Access Compliance Report

Public Rights-of-Way

(Curb Ramps)

Intersection ID: 2835	Main Street: CARDINAL_POINT_RD	Cross Street: RED_CLOVER_LN	Location: S
ADA ID: E3914DBFD7D2	Ramp Type: Perp	Initial Pass/Fail: Fail	Overall Compliance: No
Severity Score: 12.5			
Codes/Mitigation Info/Possible Solution		Field Measurements/Component Compliance

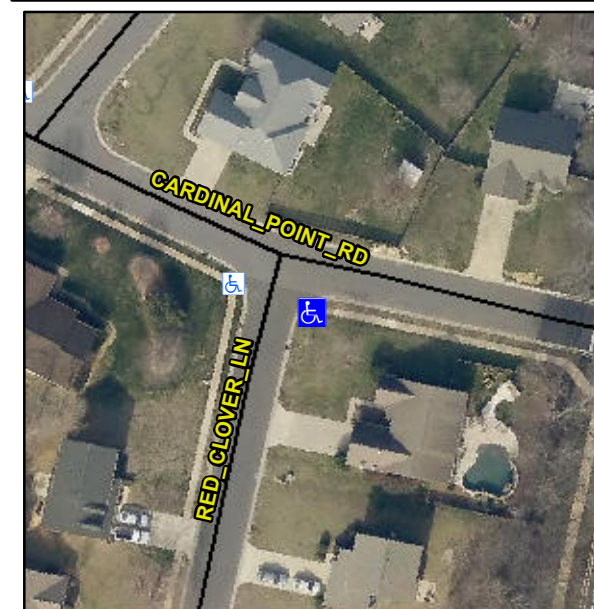
Not Found, R304.2.2

Compliance	Description	Data	Compliance	Description	Data
N/A	Ramp Length (in)	50.5	No	Ramp Slope (%)	9.8
Yes	Ramp Width (in)	48.0	Yes	Ramp XSlope (%)	0.3
N/A	Flare Type LT	N/A	N/A	Flare Type RT	N/A
N/A	Flare Slope LT (%)	N/A	N/A	Flare Slope RT (%)	N/A
N/A	Flare Traversable LT?	N/A	N/A	Flare Traversable RT?	N/A
N/A	Landing Length (in)	N/A	N/A	DWS Provided?	N/A
N/A	Landing Width (in)	N/A	N/A	DWS Contrast?	N/A
N/A	Landing Slope (%)	N/A	N/A	DWS Length (in)	N/A
N/A	Landing X Slope (%)	N/A	N/A	DWS Full Width?	N/A
N/A	Landing Curb? (Y/N)	N/A	N/A	DWS Offset (in)	N/A
N/A	Shared Landing?	N/A			
N/A	Gutter Ponding?	N/A	N/A	Gutter Slope (%)	N/A
N/A	Gutter Lip Ht (in)	N/A	N/A	Gutter X Slope (%)	N/A
N/A	Painted X Walk1?	No	N/A	Painted X Walk2?	N/A
	X Walk 1 Direction	To NW		X Walk 2 Direction	N/A
N/A	X Walk 1 Width (in)	N/A	N/A	X Walk 2 Width (in)	N/A
	X Walk 1 Slope (%)	1.0		X Walk 2 Slope (%)	N/A
	X Walk 1 X Slope (%)	1.2		X Walk 2 X Slope (%)	N/A

Possible Solutions:

Remove & Replace Entire Ramp.
